# Seismic Capacity and Strengthening Review

TRAMWAY HOTEL

114 ADELAIDE ROAD, WELLINGTON

Attachment 1- Sketches indicating concept seismic strengthening work

COMMENTS: PLAN- Ground floor level- marked up to show concept seismic strengthening works.

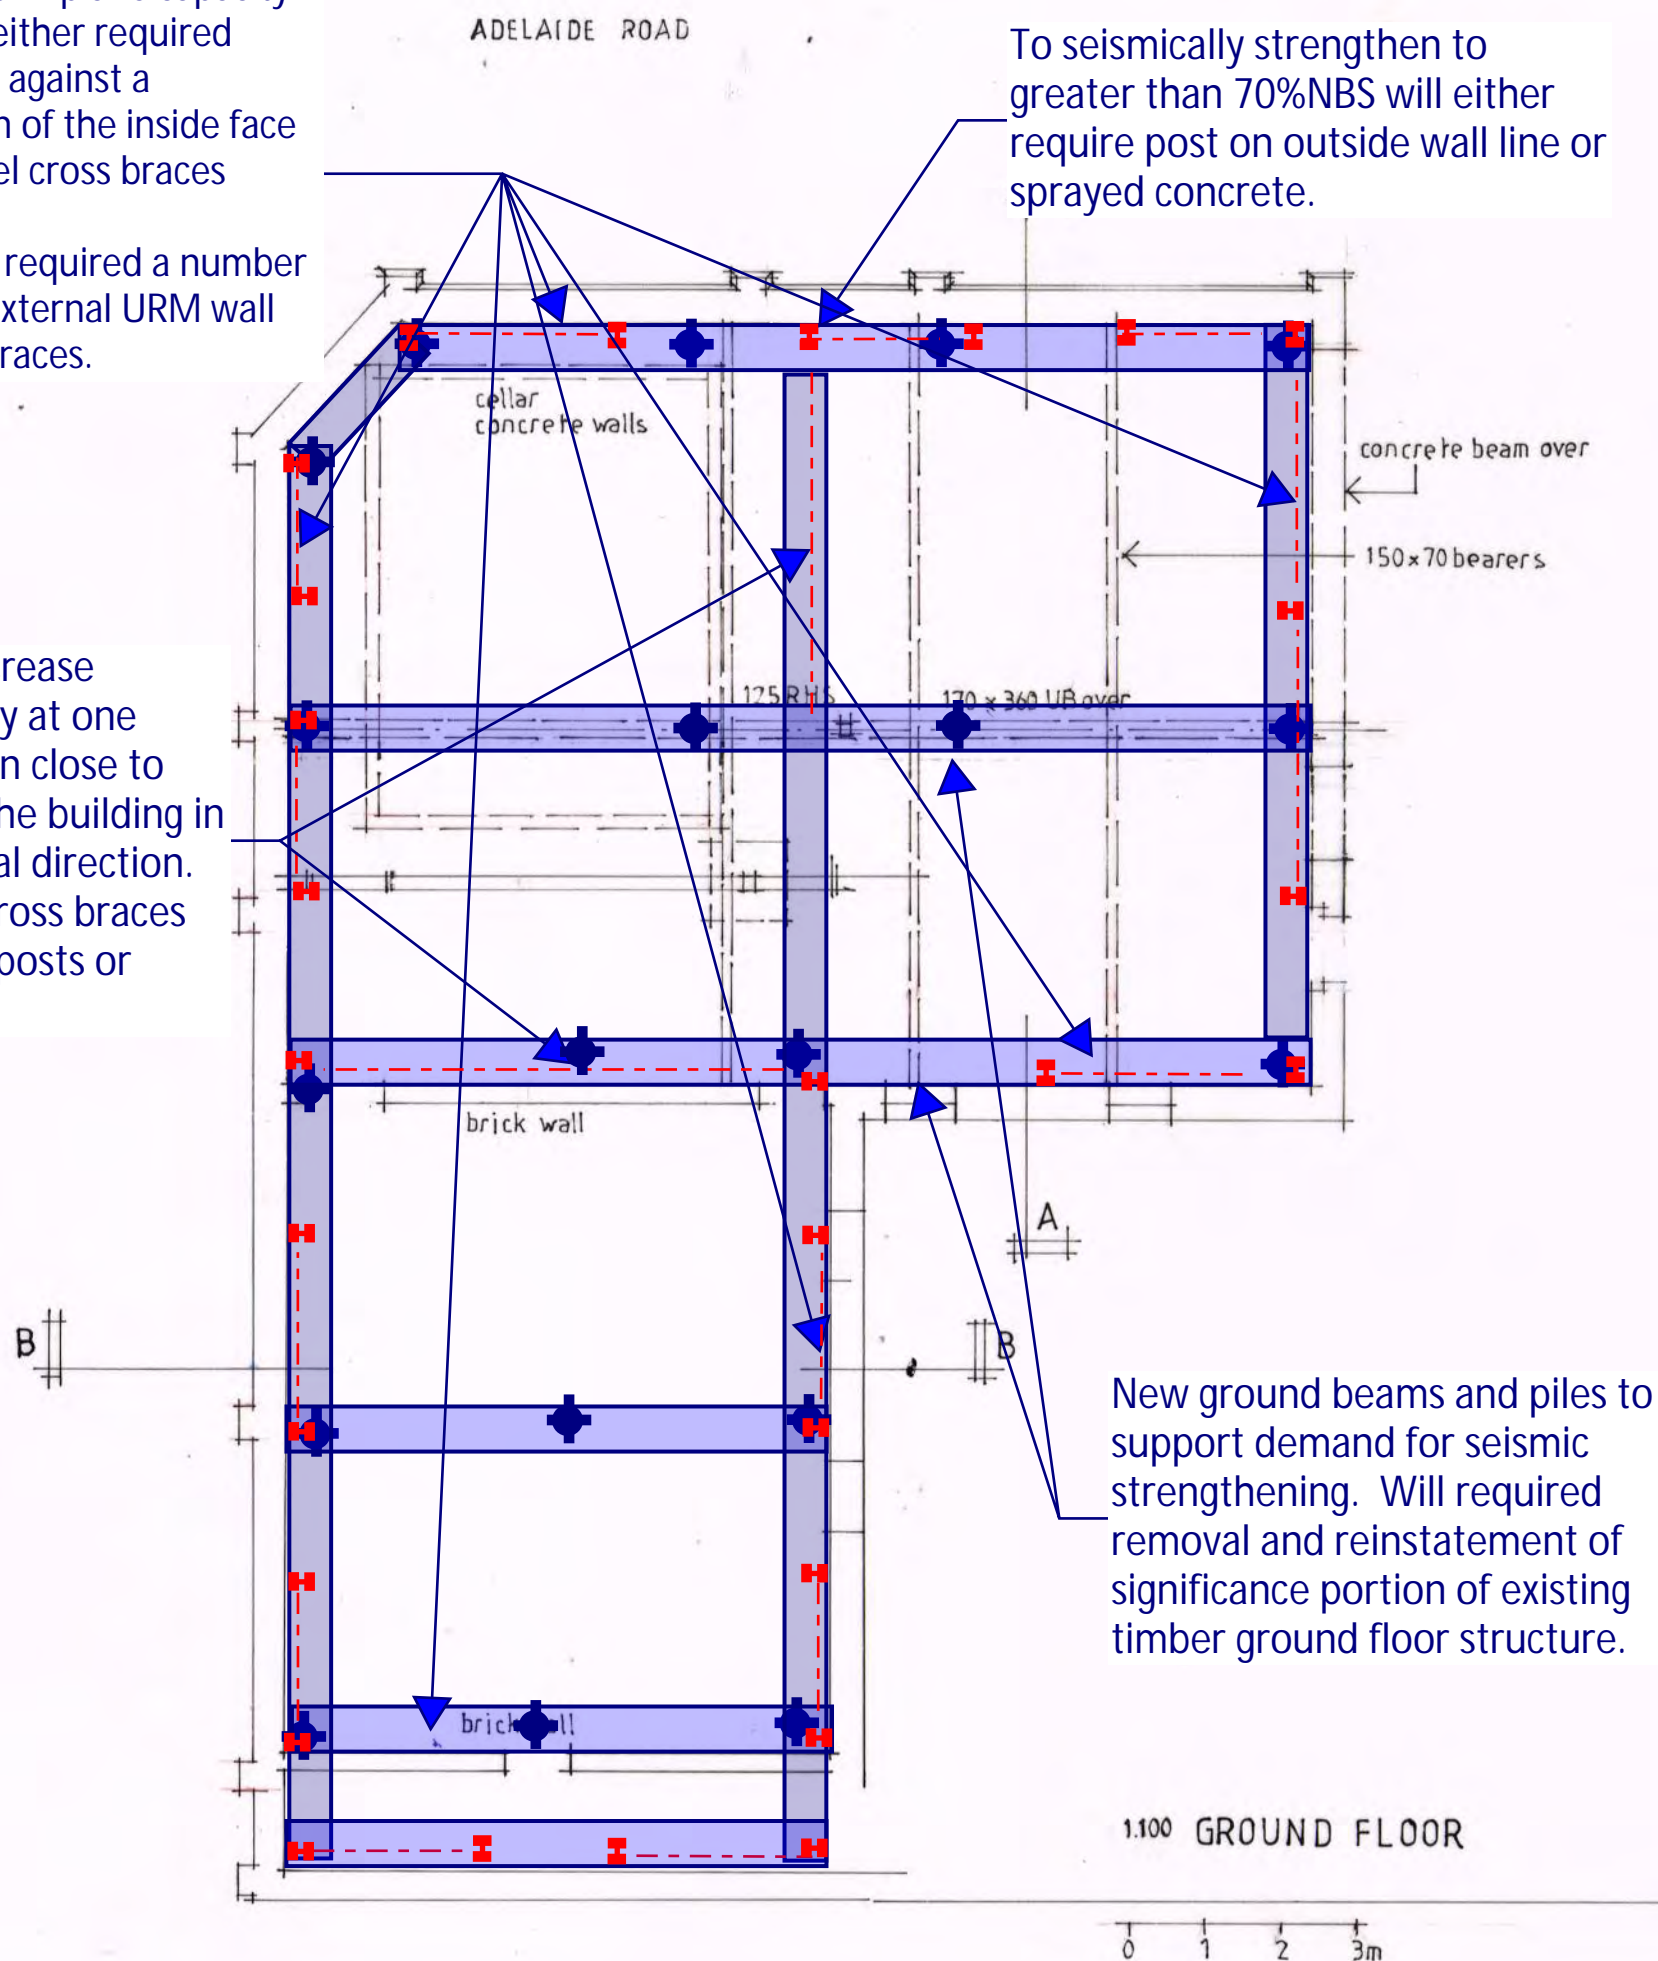
To strengthen the in-plane capacity of URM wall will either required sprayed concrete against a significant portion of the inside face of the wall or steel cross braces between post.

If cross bracing is required a number of bays on each external URM wall line will require braces.

Will require increase bracing capacity at one internal location close to the middle of the building in each orthogonal direction. This could be cross braces between steel posts or concrete walls.

To seismically strengthen to greater than 70%NBS will either require post on outside wall line or sprayed concrete.

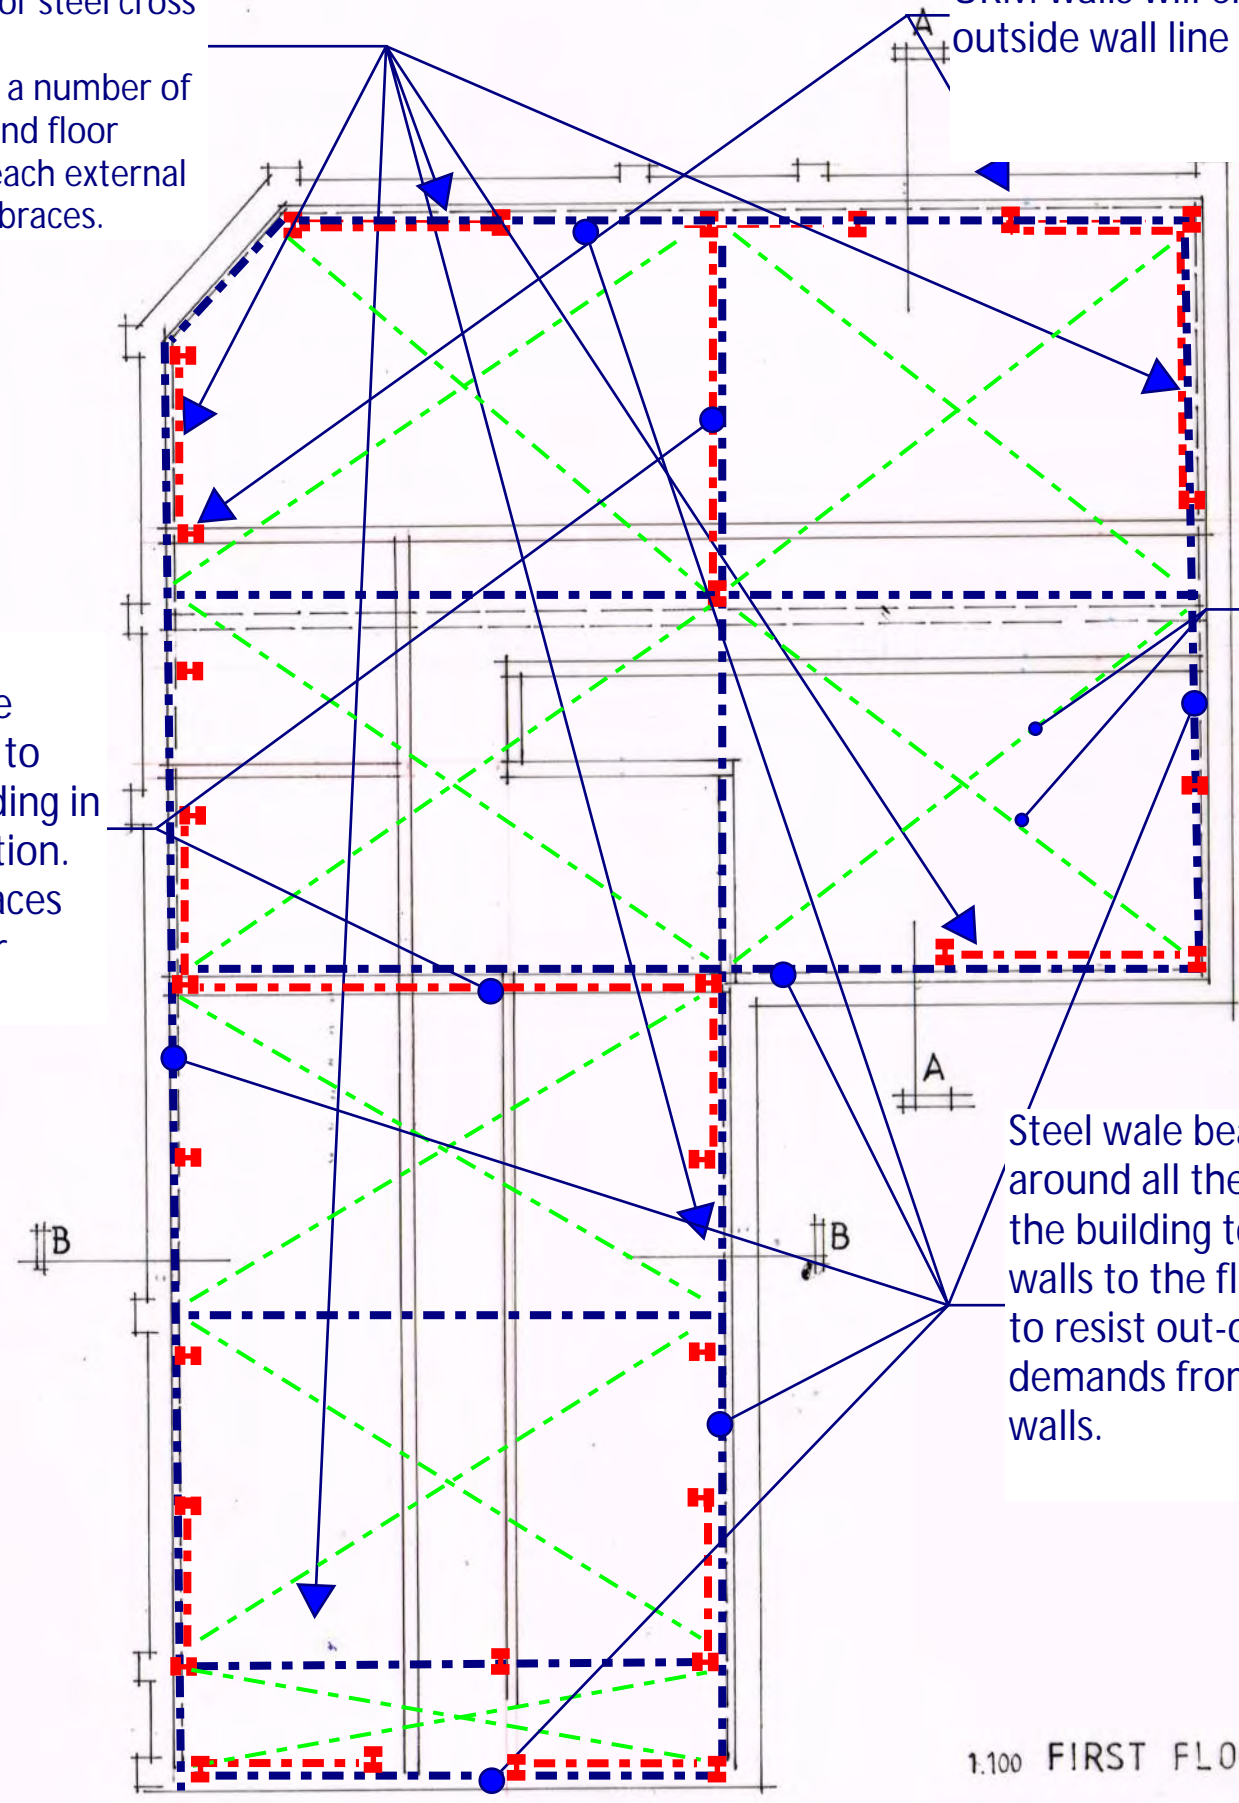
To strengthen the in-plane capacity of URM wall will either required sprayed concrete against a significant portion of the inside face of the wall or steel cross braces between post.  
 If cross bracing is required a number of bays (but less than at ground floor level) will be required on each external URM wall line will require braces.

To seismically strengthen to greater than 70%NBS against out-of-plane demands on URM walls will either require post on outside wall line or sprayed concrete.

Will require increase bracing capacity at one internal location close to the middle of the building in each orthogonal direction. This could be cross braces between steel posts or concrete walls.

Steel cross braces in or under the plane of the floor structure to increase the diaphragm capacity at first floor level.

Steel wale beam required around all the perimeter of the building to tie the URM walls to the floor diaphragm to resist out-of-plane demands from the URM walls.

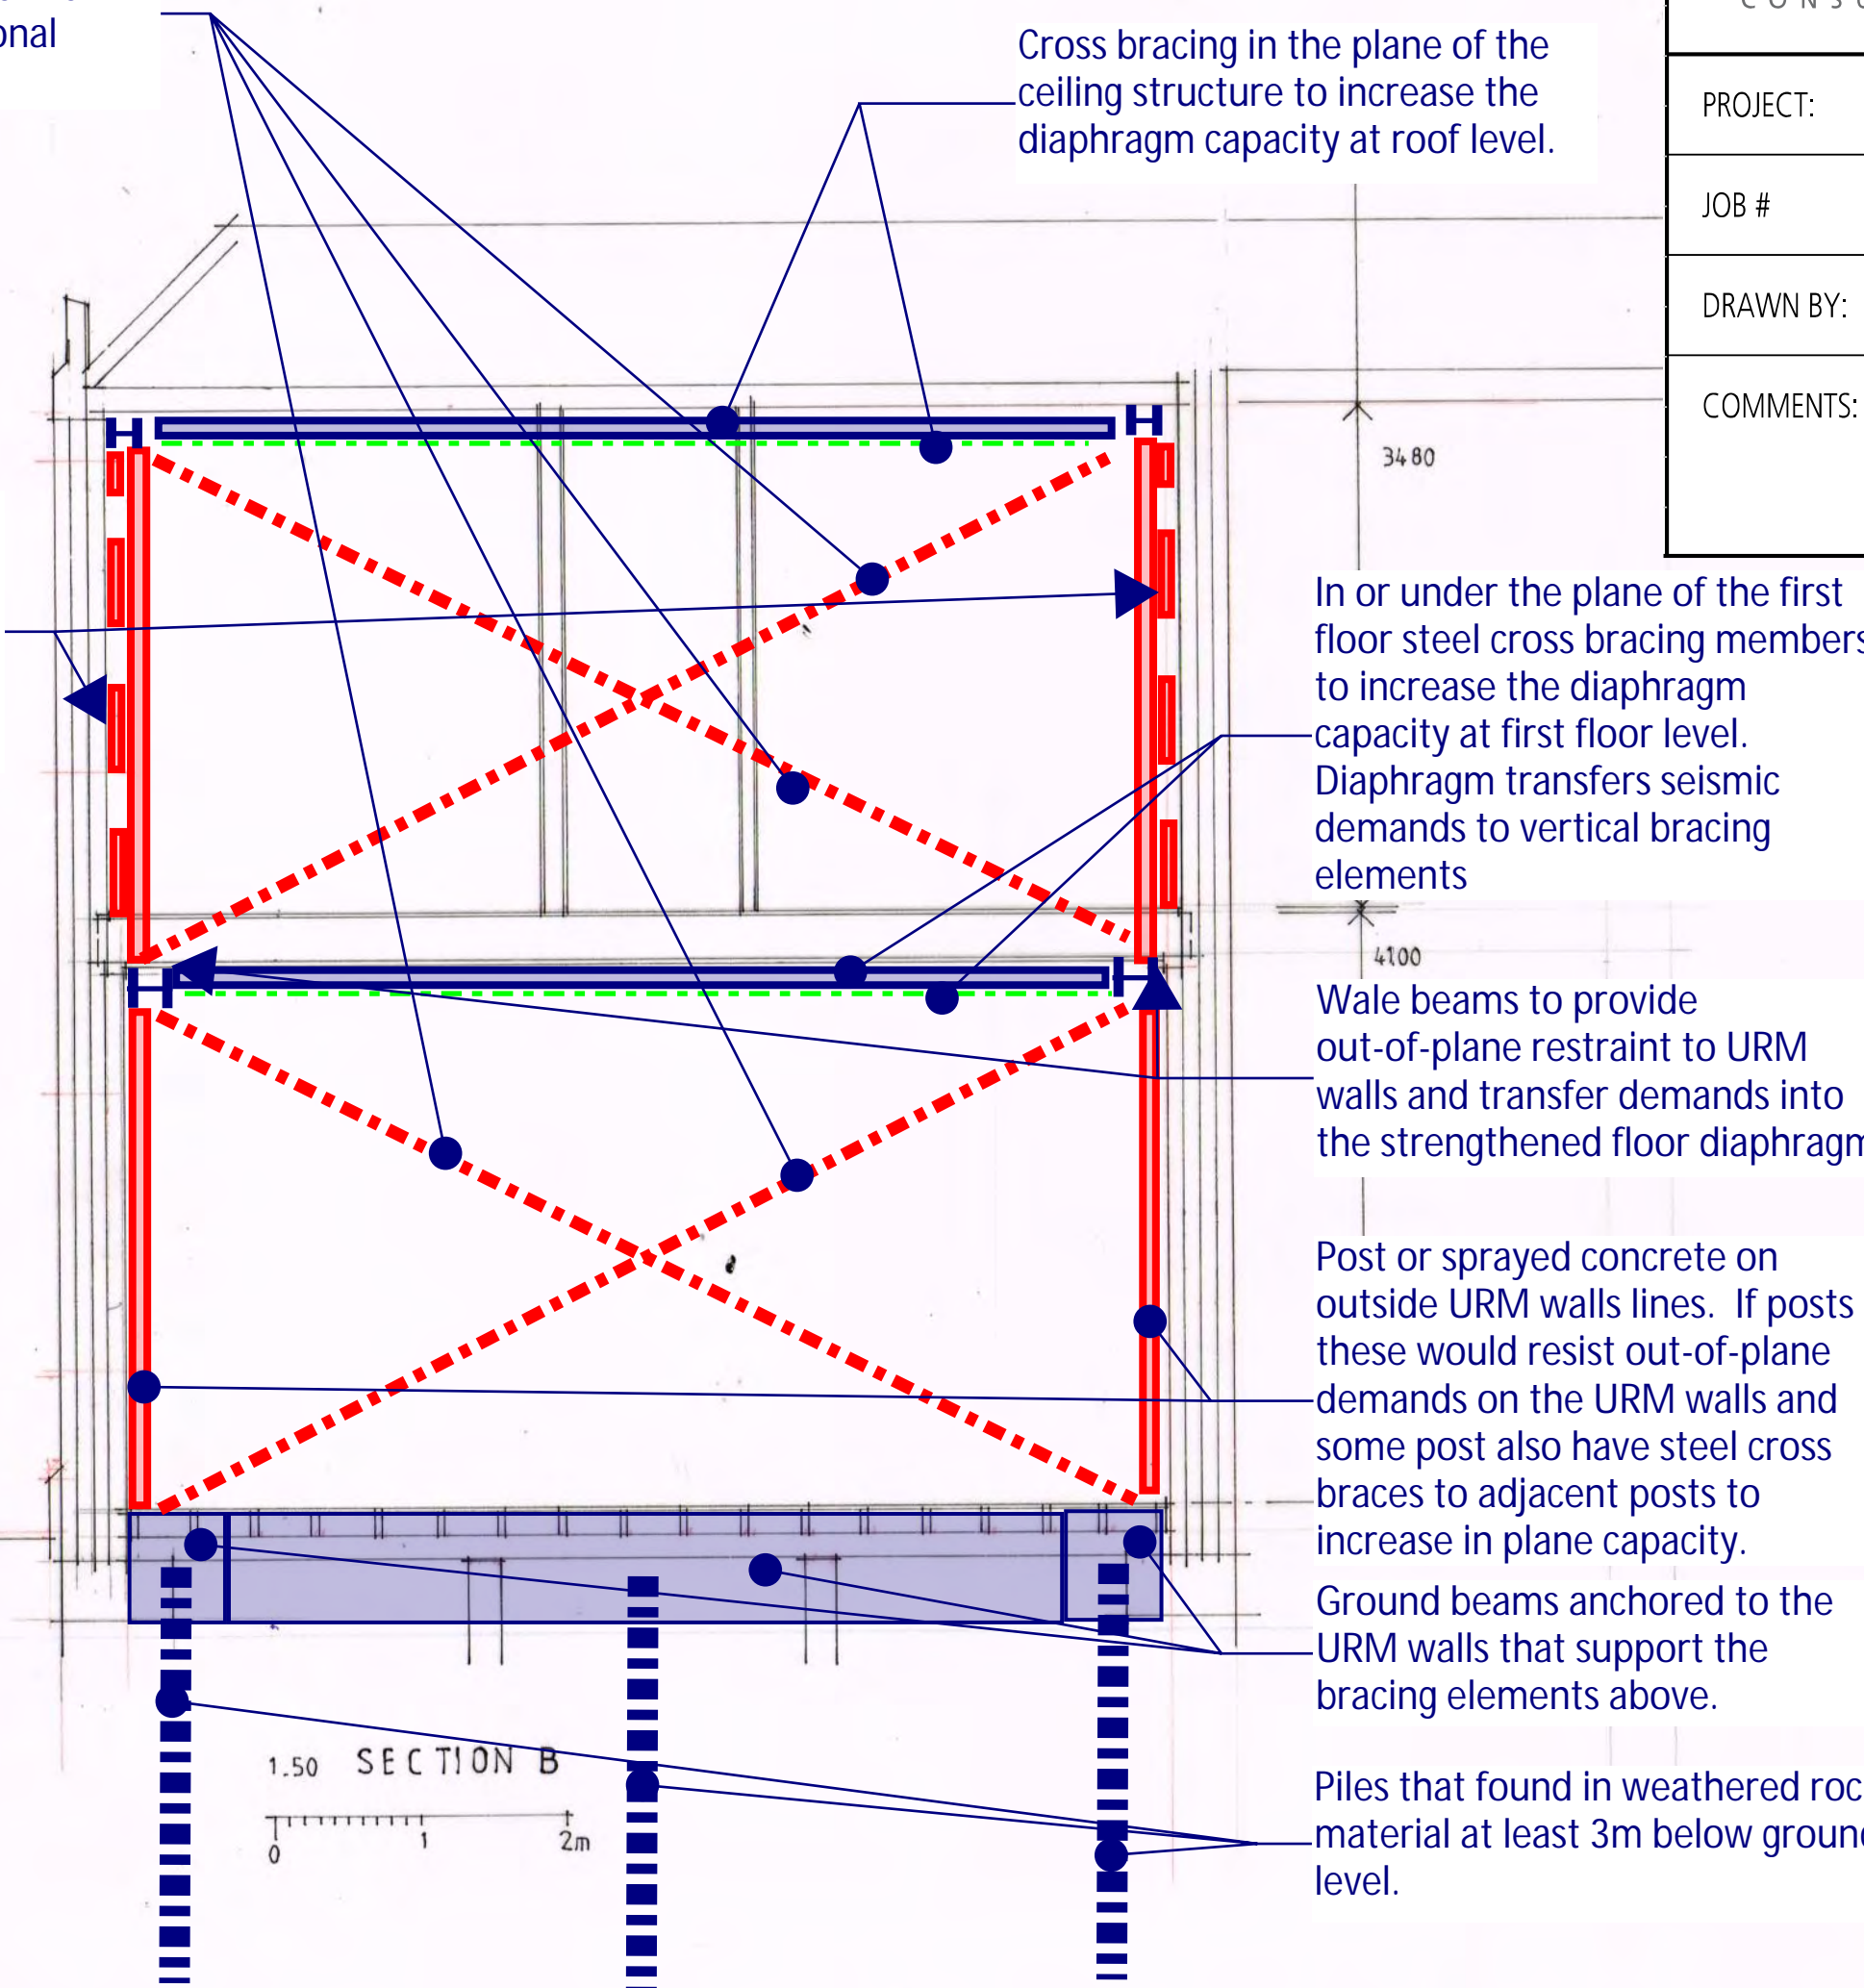
Internal cross bracing or concrete shear walls on two internal wall lines, one in each orthogonal direction.

Cross bracing in the plane of the ceiling structure to increase the diaphragm capacity at roof level.

If posts used will require packers at first floor level to allow for the reduction in wall thickness at first floor level.

In or under the plane of the first floor steel cross bracing members to increase the diaphragm capacity at first floor level. Diaphragm transfers seismic demands to vertical bracing elements

Wale beams to provide out-of-plane restraint to URM walls and transfer demands into the strengthened floor diaphragm.

Post or sprayed concrete on outside URM walls lines. If posts these would resist out-of-plane demands on the URM walls and some post also have steel cross braces to adjacent posts to increase in plane capacity.

Ground beams anchored to the URM walls that support the bracing elements above.

Piles that found in weathered rock material at least 3m below ground level.
